PBK, P.O. BOX 880, GRIFFIN, GA 30223

ADDENDUM NUMBER FOUR: DATED: October 22, 2026

To: All prime contract bidders of record.

This addendum forms a part of the Contract Documents and modifies the original Specifications and Drawings dated September 11, 2026, as noted below. **Acknowledge receipt of this Addendum in the space provided on the Bid Form;** failure to do so may subject bidder to disqualification.

1 ENLARGED MEDIA CENTER PLAN

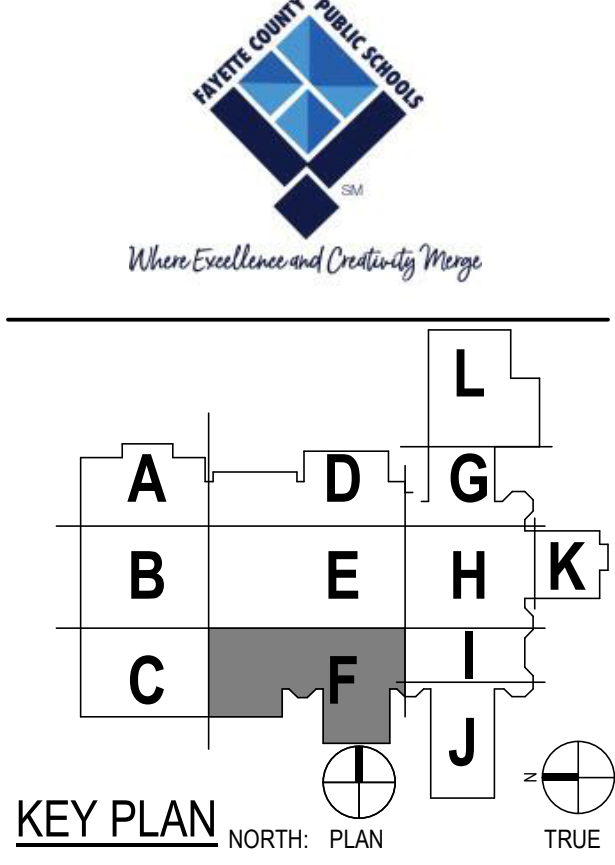
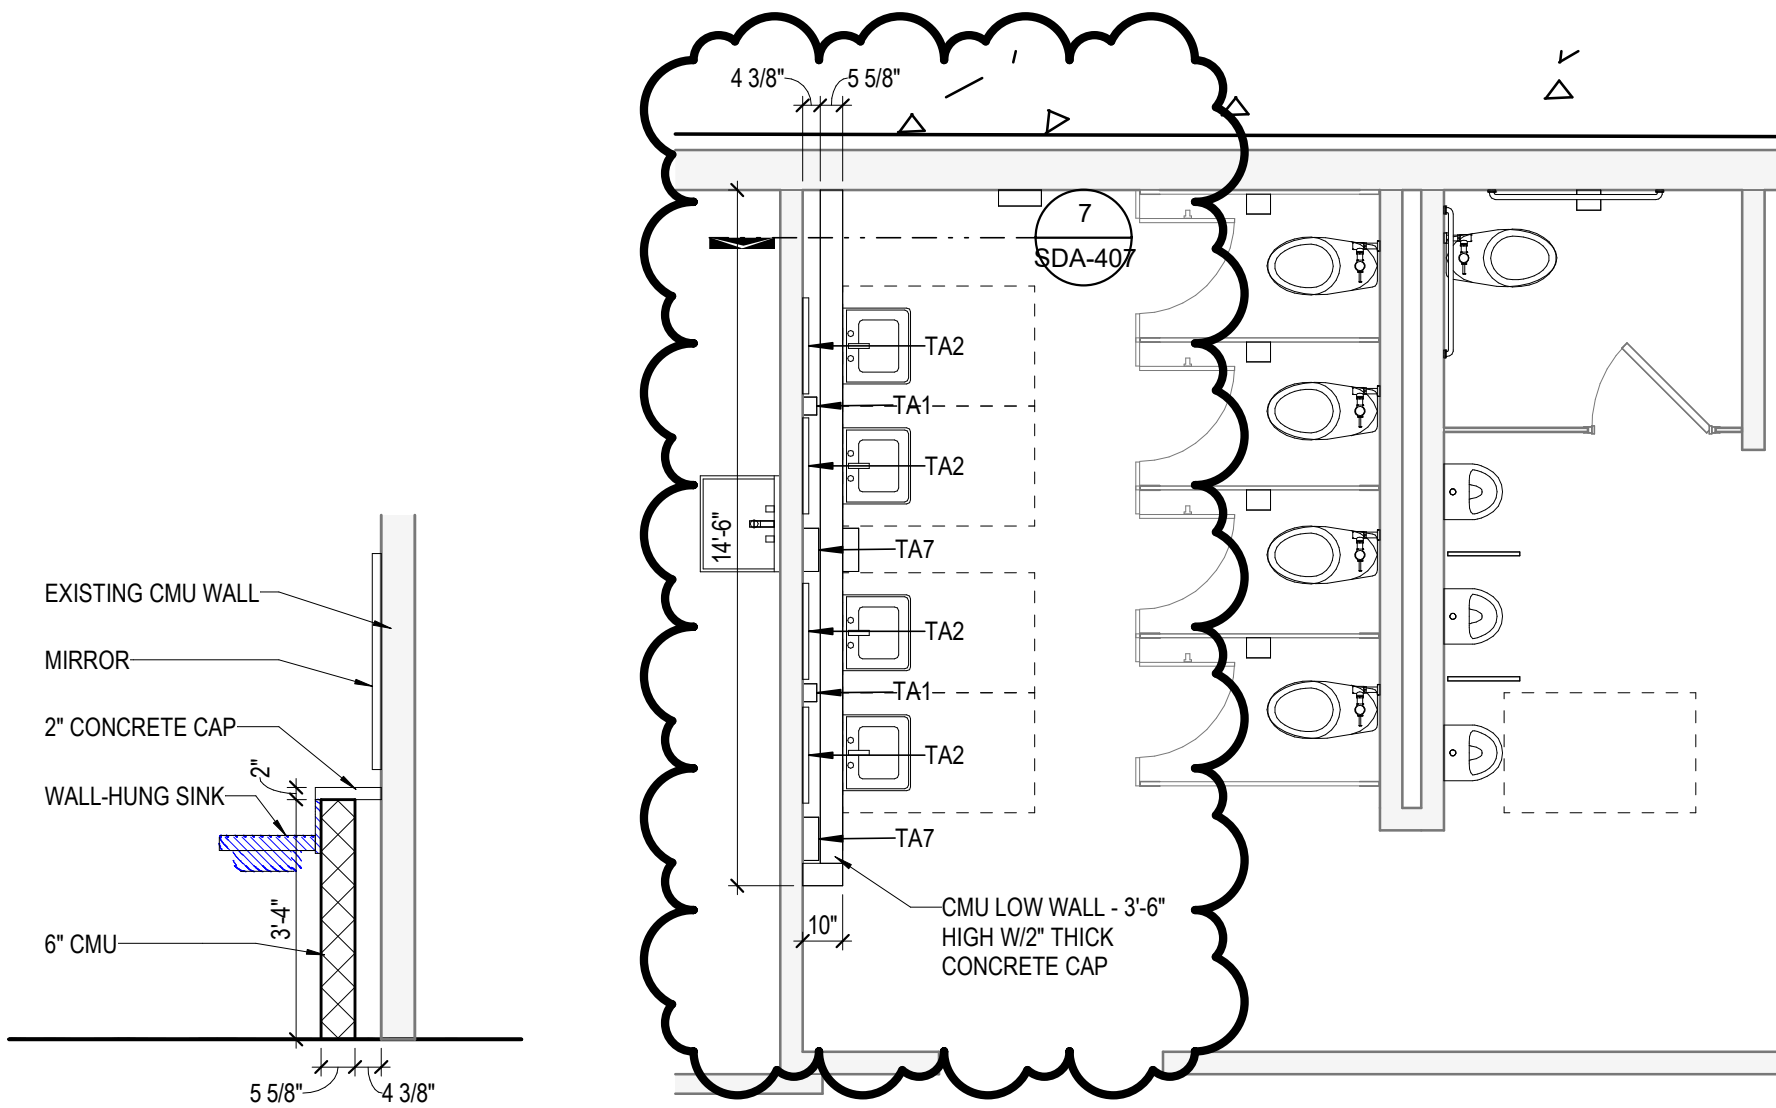
1. Revisions to casework for the media center also reflected in reissuance of Sheet A-401 later in this addendum.

- A. Delete Sheet A-401 in its entirety and replace with Sheet A-401 included in this addendum.

7 SECTION DETAIL
3/8" = 1'-0"

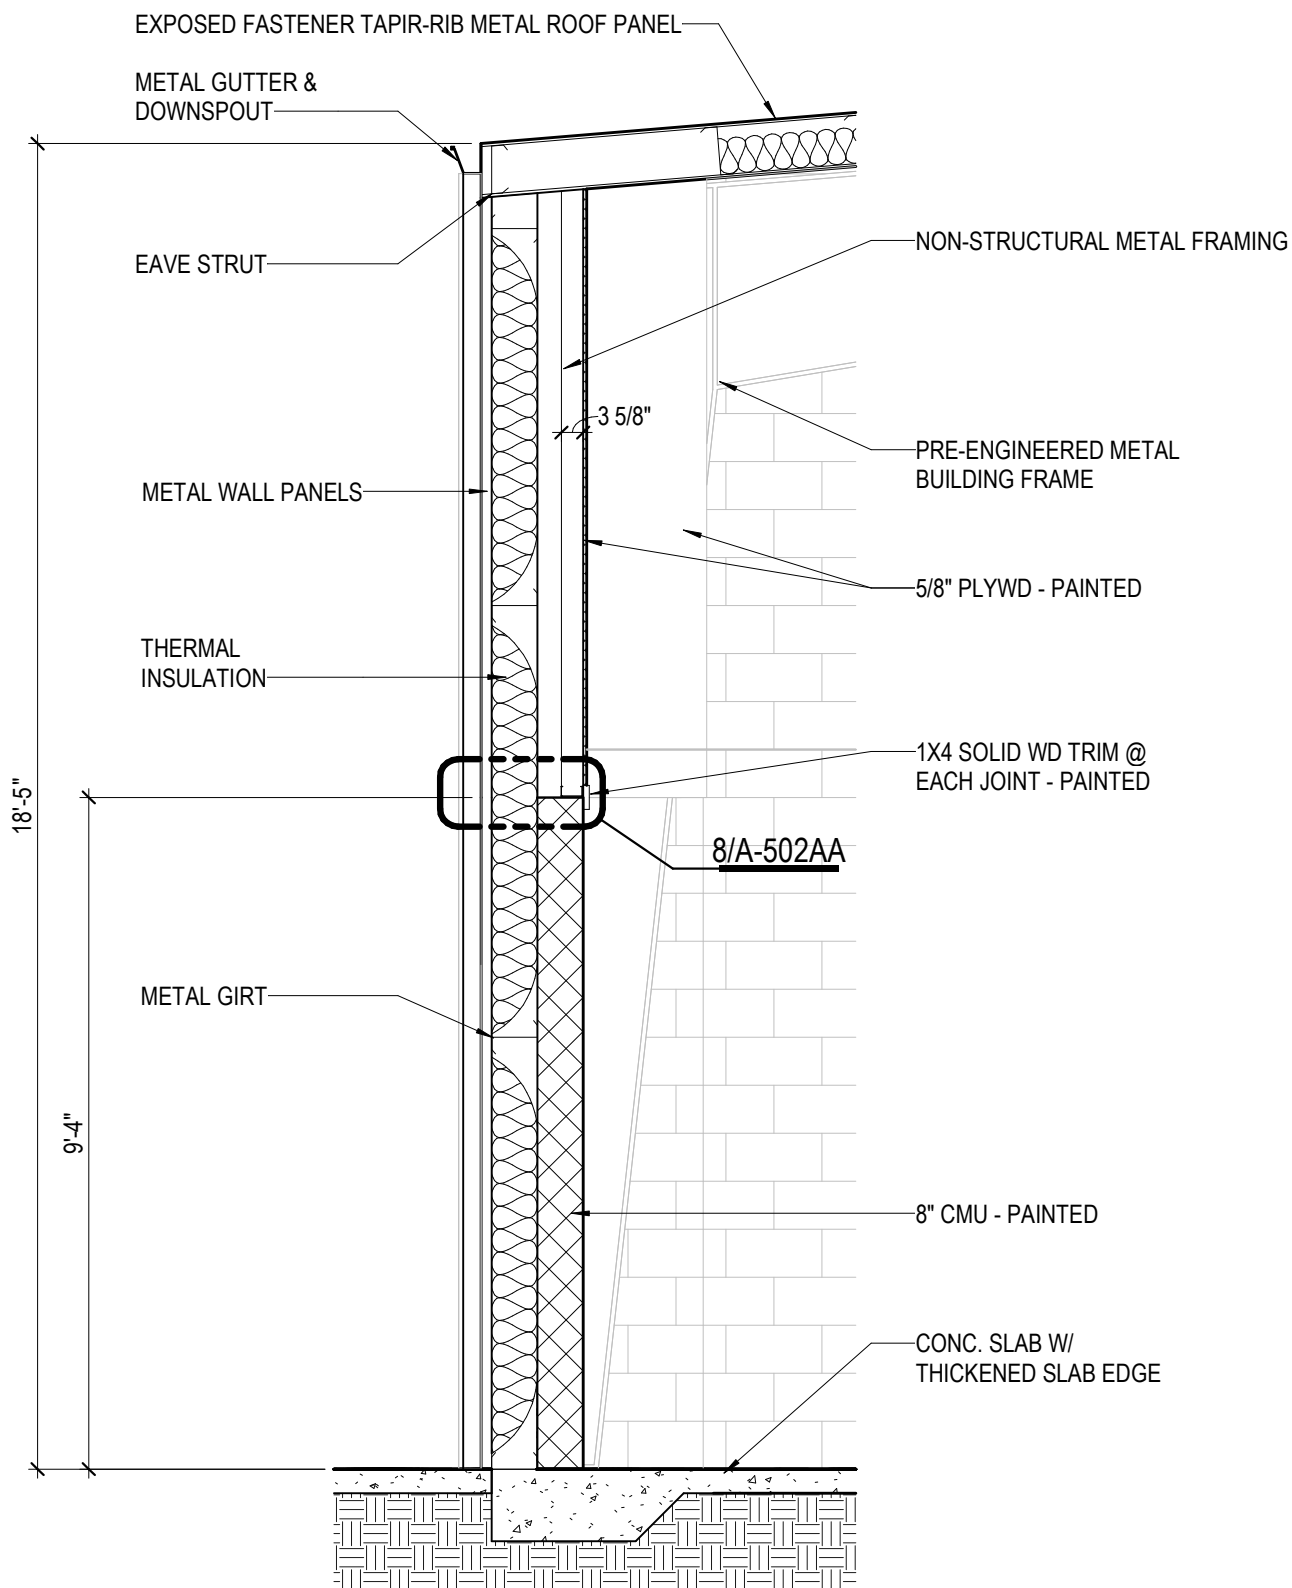
- B. Add Detail No.7 – SECTION DETAIL included on SDA-407 included in this addendum.

- 1. Section detail for chase wall in Restroom 2 noted above.
